FILE #SPR-95-210

TITLE HEADING: Site Plan Review - New Building
and Expansion of Current Building

LOCATION: 560 25 Road

PETITIONER: Ute Water Conservancy District

SITE PLAN & LANDSCAPE PLAN
PROPOSED EXPANSION

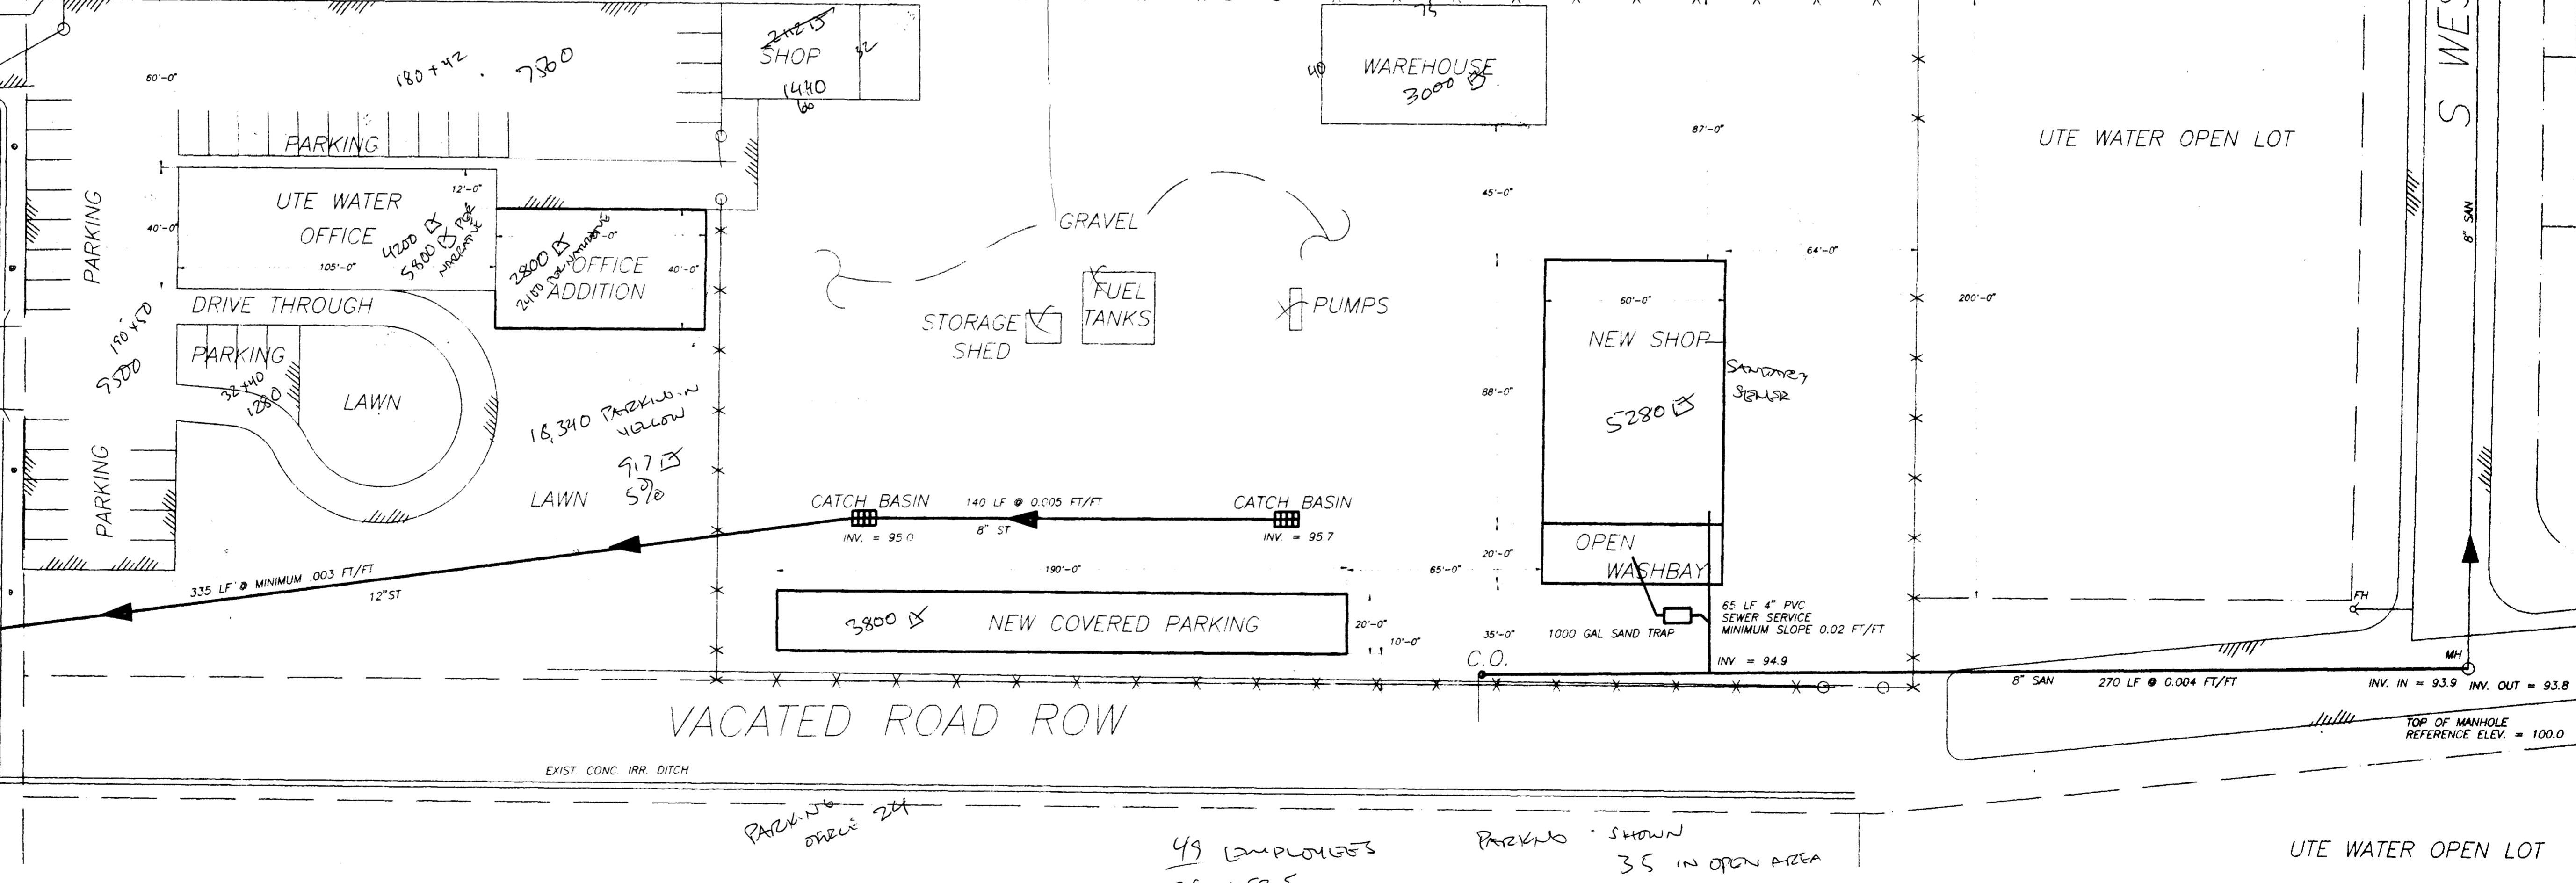
C-2
 PARKING - OK
 45 SPACES
 915s - OK

NEED TO USE GRADES FOR CONC
